**BUFFALO COLOR
AREA "D" SITES
SITE Nos. 9-15-012A&B**

RECORD OF DECISION

**PREPARED BY
NEW YORK STATE DEPARTMENT OF
ENVIRONMENTAL CONSERVATION**

New York State Department of Environmental Conservation
Responsiveness Summary
for
Proposed Remedial Action Plan
Buffalo Color Sites
Site Nos. 9-15-012 A&B
Buffalo, New York

EXISTING SITE
CONDITIONS PLAN

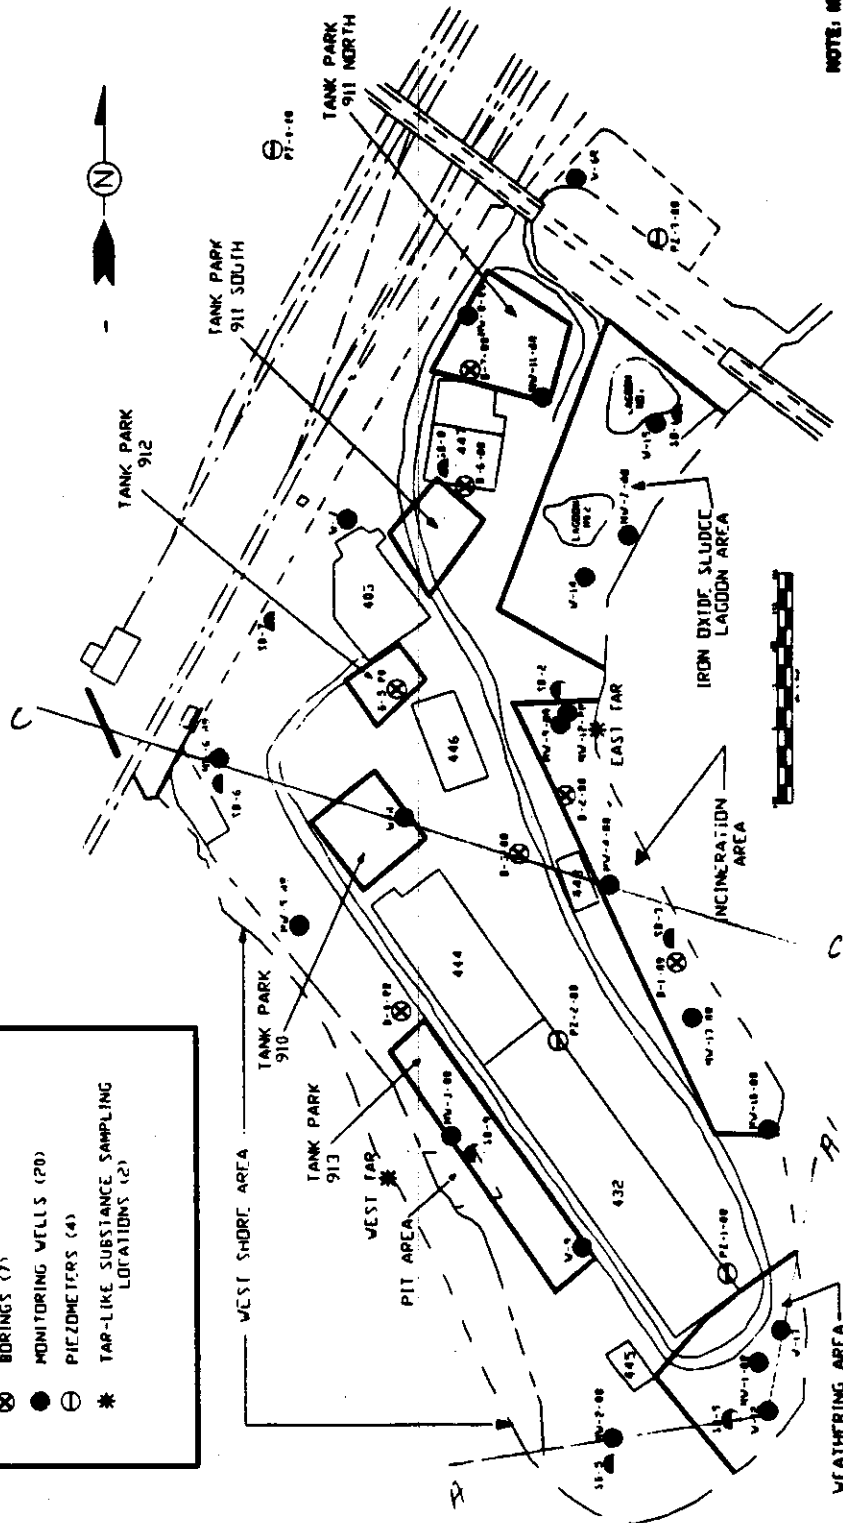
Question: How about if you do this plan (Alternative 6c) but excavate maybe half of the soil? We have a couple of hot spots shown on this map. The tank park area and the lagoon area. Are you going to do anything about those hot spots?

Answer: During remedial investigation, a lighter phase of NAPL was discovered in the trailer park Area 910, and incineration area. The Department considered these two areas to be hot spots and asked the PRPs to recover the NAPL. An attempt was made by the responsible parties to recover the NAPL as an Interim Remedial Measure (IRM), using existing wells. However, the recovery of NAPL was extremely slow. In the proposed perimeter leachate collection system, NAPL will be captured through fan shaped drainage collection system in the two known areas where NAPL exists. An oil/water separator will separate the NAPL and leachate for disposal/treatment. In addition, the iron lagoon area, the weathering area and the incineration area are labelled as hot spots on the map based on the historical use of these areas. Analytical results of the soil samples collected from other areas of the site indicates existence of waste material throughout the site. While some areas contain high levels of heavy metals others contain high levels of Polycyclic Aromatic Hydrocarbons (PAHs) and other organics. Due to the widespread nature of contaminants, it will be difficult to define what constitute hot spots and what is the extent of these hot spots.

ALTERNATIVE 6c SCHEMATIC

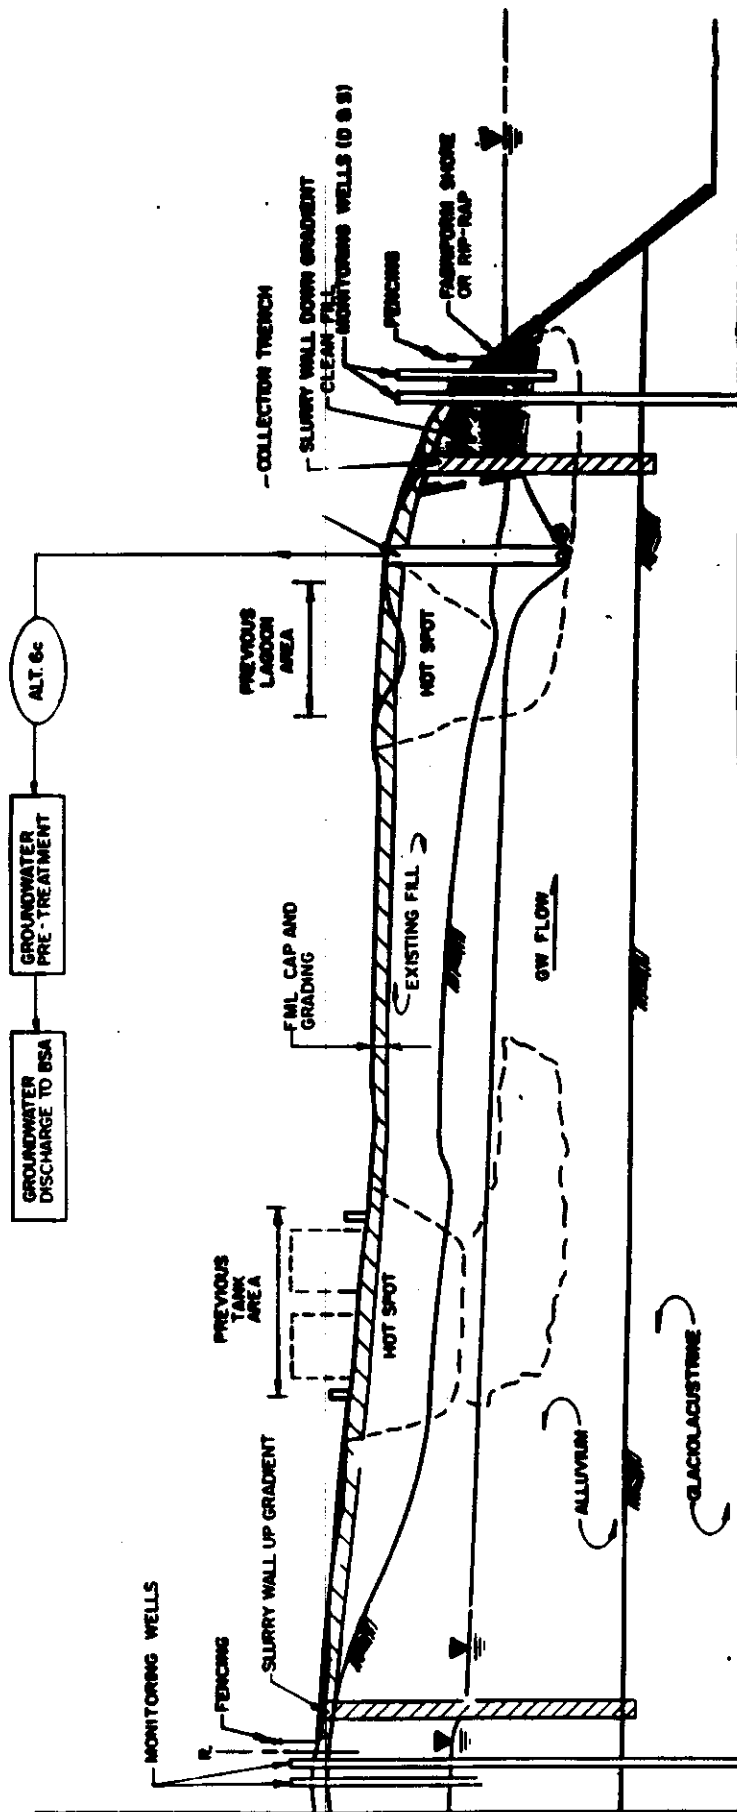
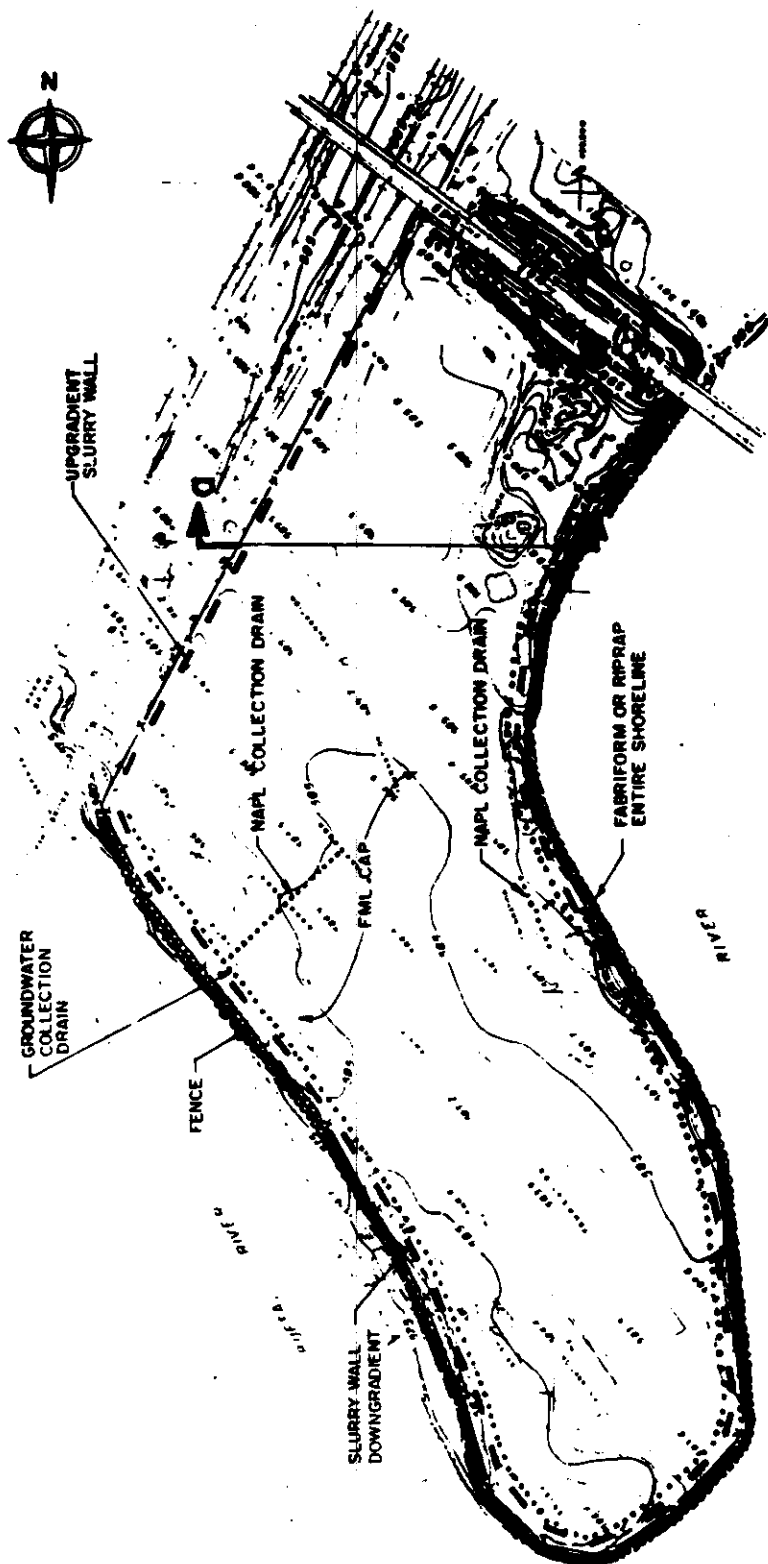
Question: Referring to Alternative 6c schematic: In the proposed remedial alternative when you install the slurry wall, the waste/sediment outside the wall (along the river bank) will be taken out and put back on the other side of the wall. Why? If you are going to take it out, get rid of it. Neutralize it completely. Don't throw it back in. Why dump it into a larger area and make the larger area more contaminated?

Answer: Due to construction difficulties the slurry wall cannot be installed right against the water. Installing the slurry wall approximately 20 to 30 feet inward resulted in leaving some contaminated soil outside the containment system which was not acceptable to the Department. Therefore, the original proposal was revised to address this problem. The revised proposal not only addressed the contaminated soil outside the slurry wall, but the sediments on the bank of the river. This offered an additional advantage of installing the slurry wall in clean fill rather than against the waste material. The revised proposal calls for the excavation of the waste/sediments from the proposed location of the slurry wall upto the River bank, placing the excavated waste within the containment and replacing the excavated area with clean fill. The slurry wall then will be installed in the clean fill. The sediments are less contaminated as compared to the waste material. Therefore, placing the sediments in the
